**DOCUMENT 00 90 00  
ADDENDUM**

**ADDENDUM NO. [1]                      Date: May 7, 2019**

**RE:                      HOUSING AUTHORITY OF LA CROSSE  
2018-19 CAPITAL IMPROVEMENT PROJECTS  
1307 BADGER STREET  
LA CROSSE, WI 54601  
HSR PROJECT NO. 18065**

**1 FIRST FLOOR**  
1/8" = 1'-0"

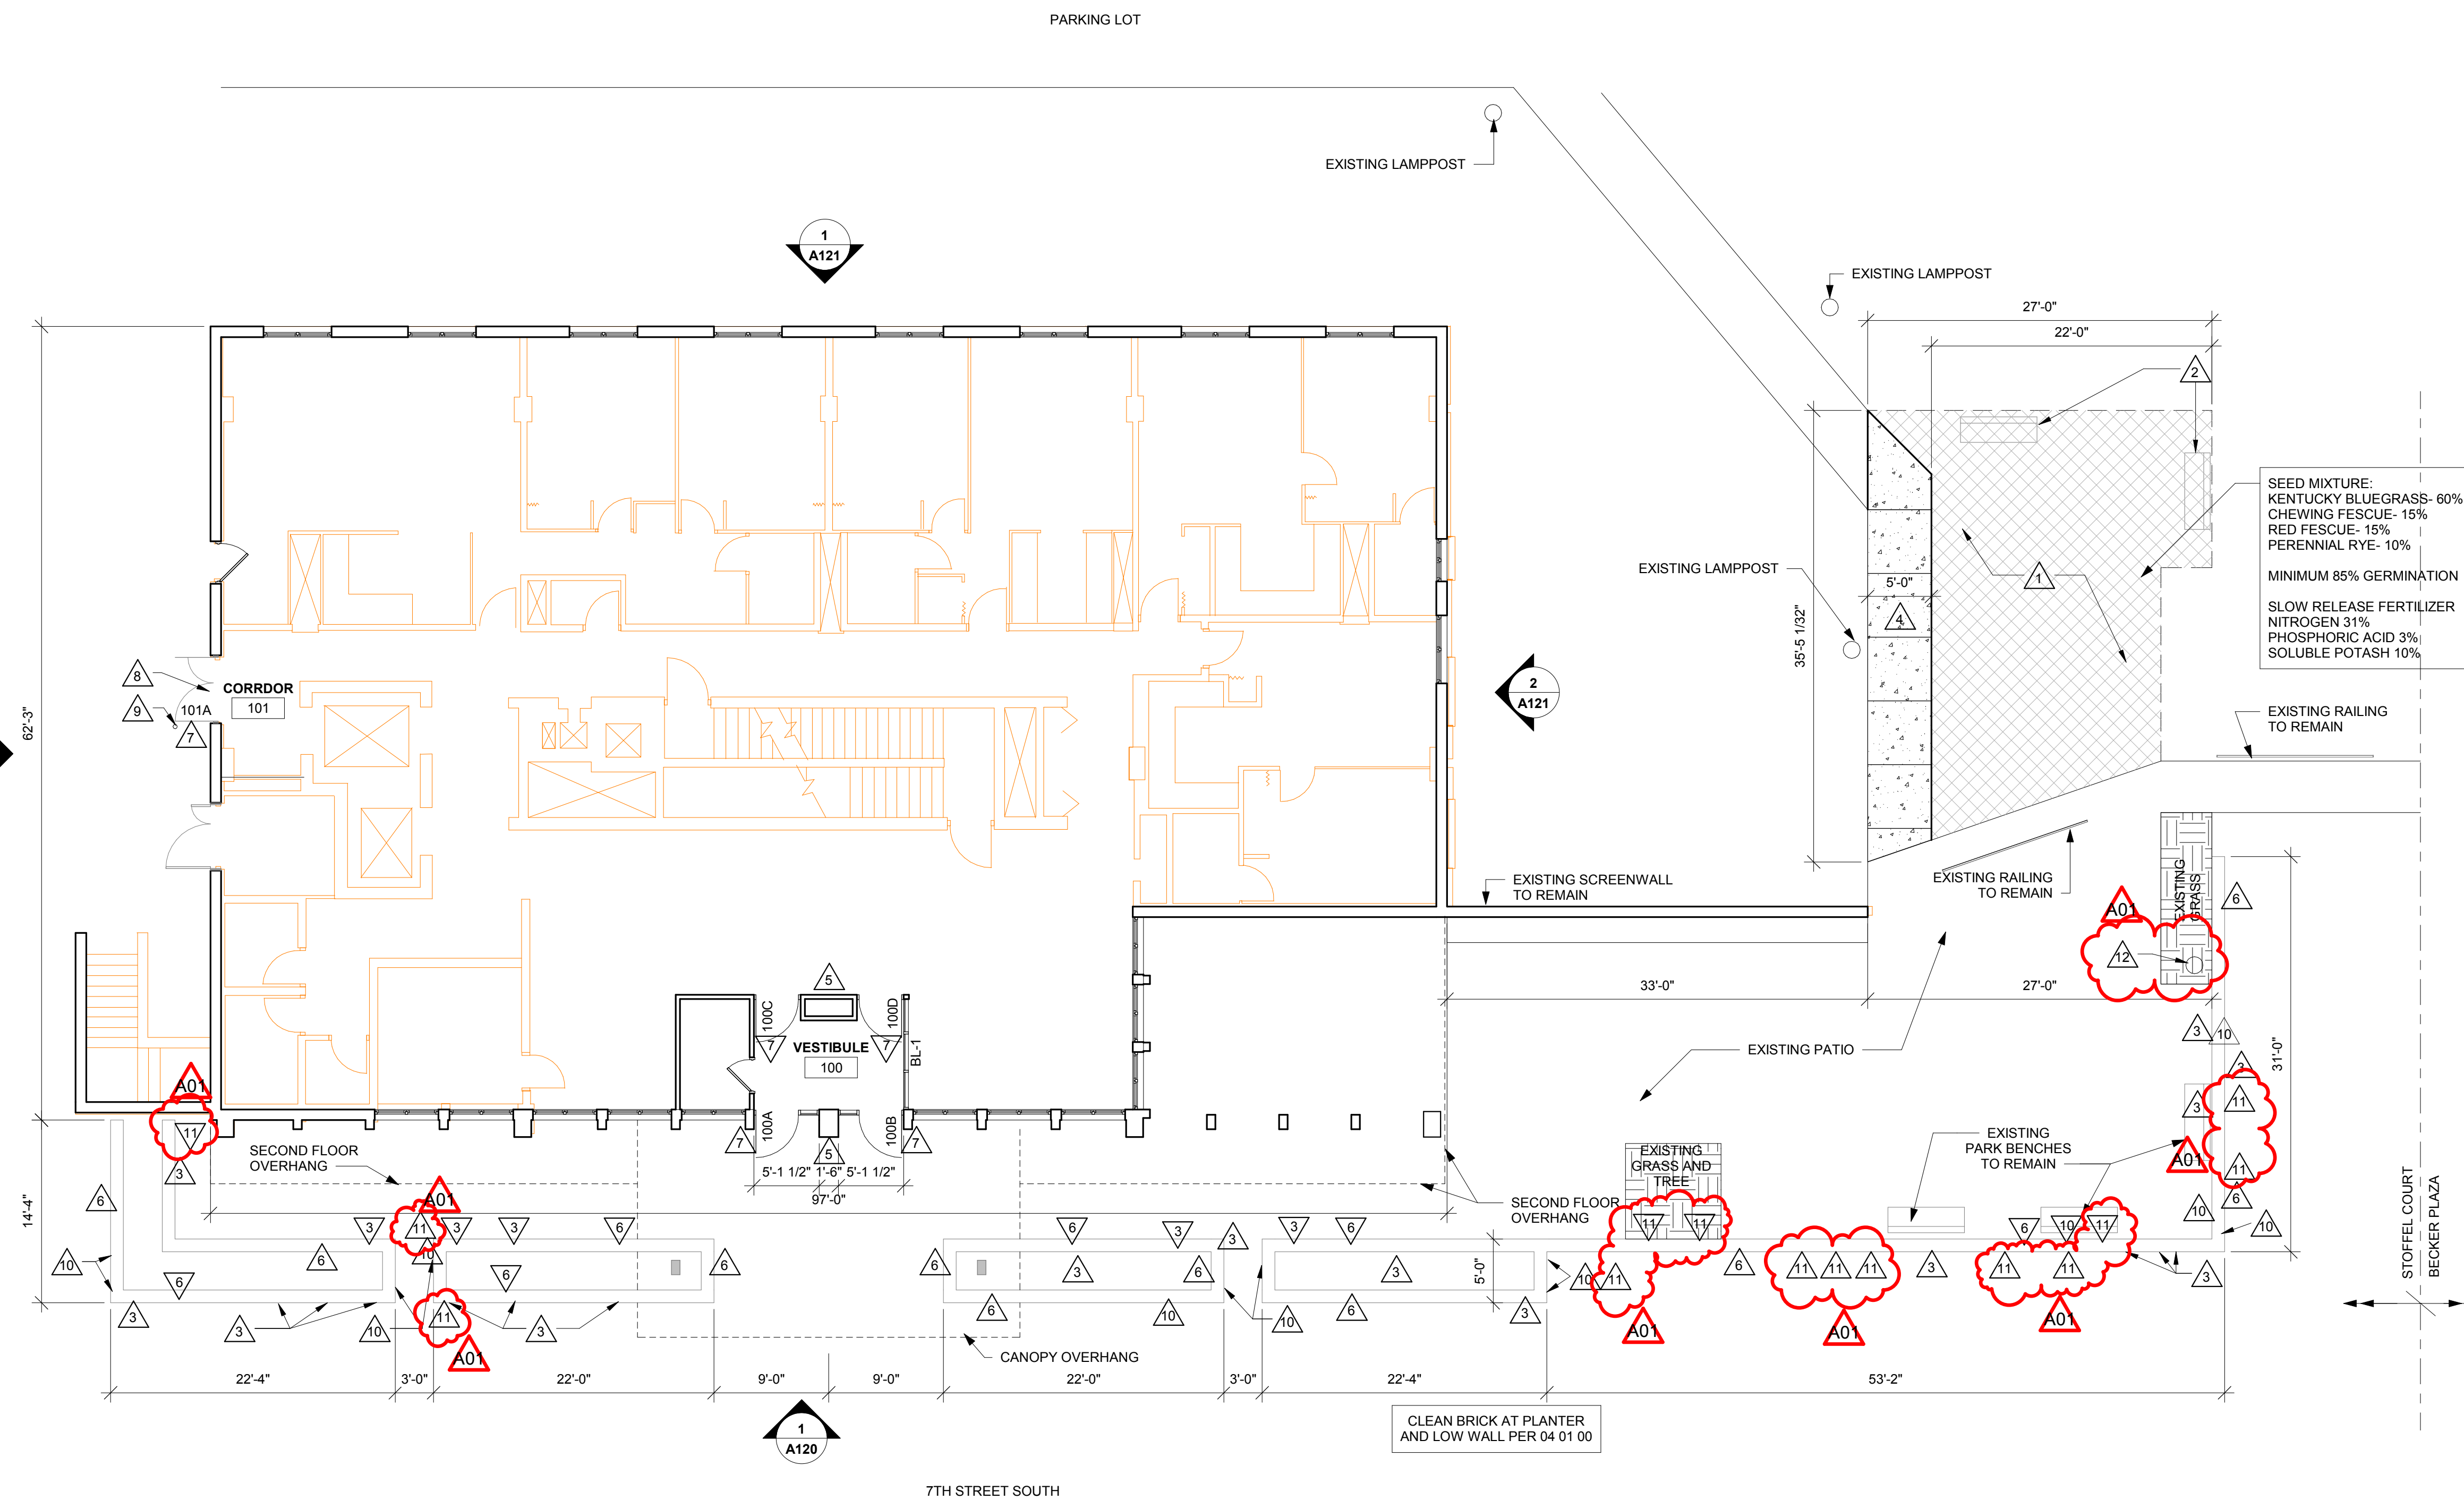
- 6. Sheet A100 FIRST FLOOR PLAN – STOFFEL COURT 30 x 42 attached hereto
  - a. Revisions clouded on Drawing
  - b. Revised Keynote 10, added Keynotes 11 and 12.

- c. Added key notes 11 and 12.
- 7. Sheet A200 FLOOR PLAN – BECKER PLAZA 30 x 42 attached hereto
  - a. Revisions clouded on Drawing.
  - b. Revised key note 3.

**A360**

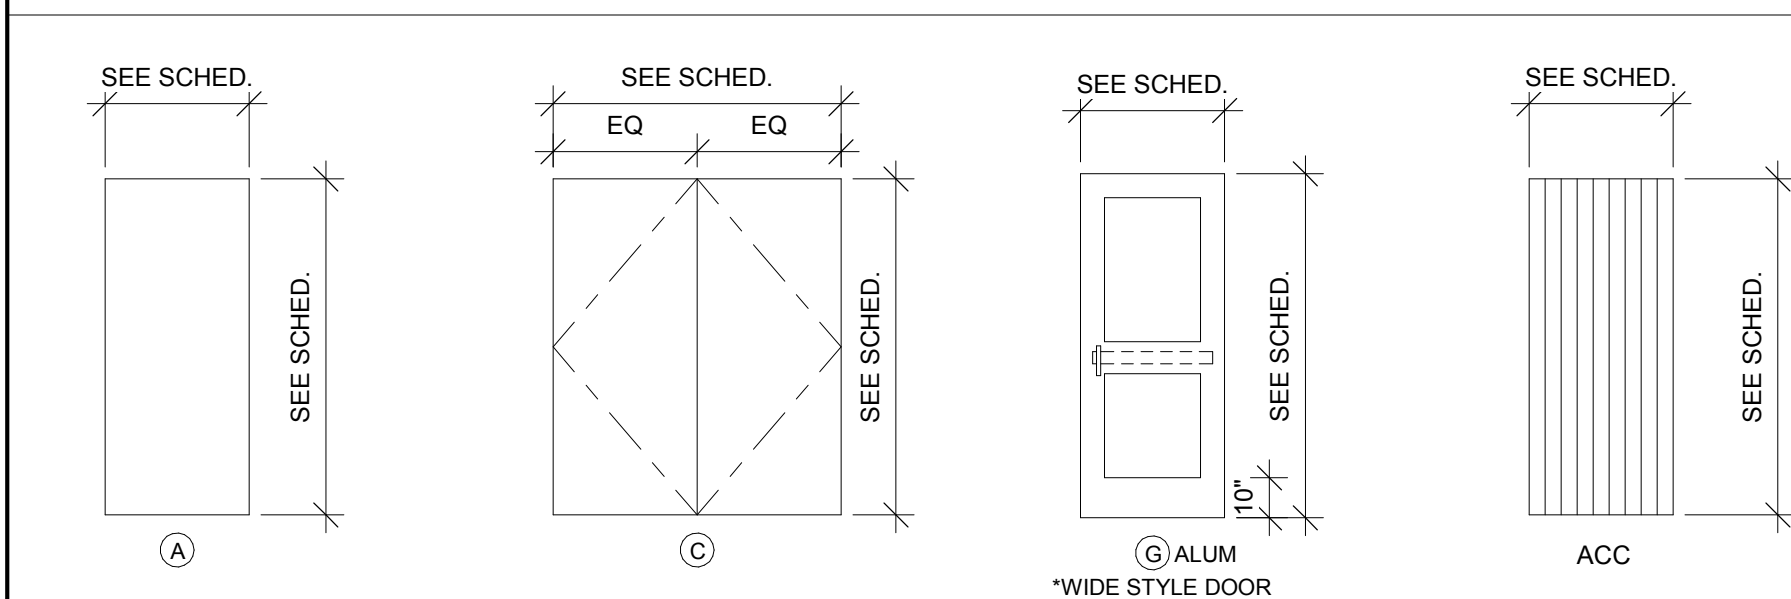
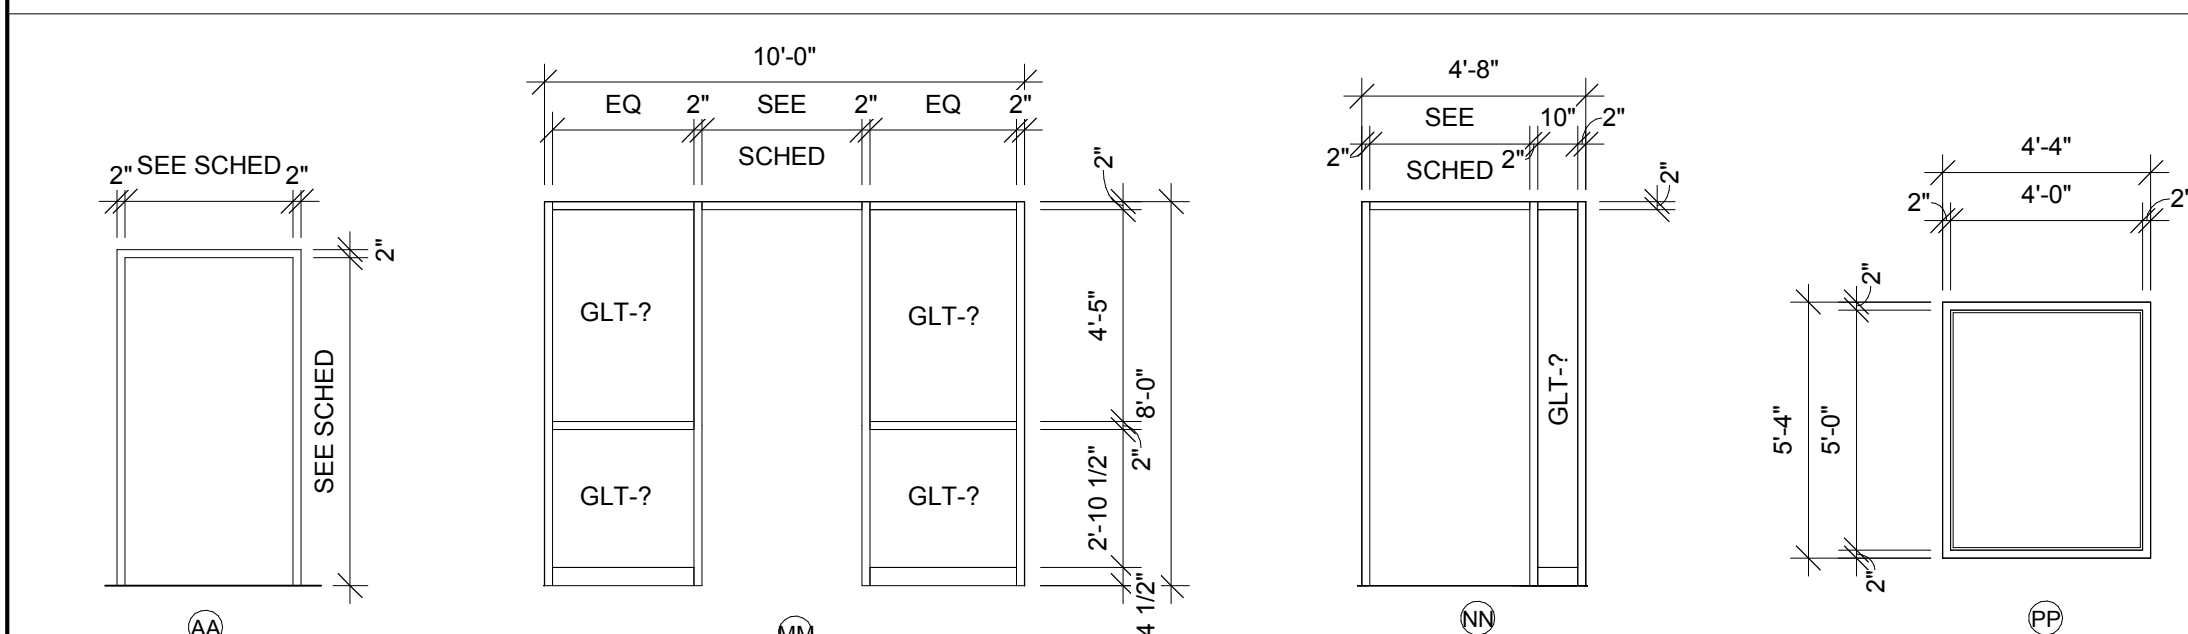
- 8. Sheet A360 DOOR SCHEDULE – SOLBERG HEIGHTS 30 x 42 attached hereto
  - a. Revisions clouded on Drawing.
  - b. Changed solid core wood doors to hollow metal as clouded on schedule.

- c. All entry door frame dimensions shall be field verified prior to ordering doors.
- 9. Sheet E100 FIRST FLOOR ELECTRICAL PLAN – STOFFEL COURT 30 x 42 attached hereto
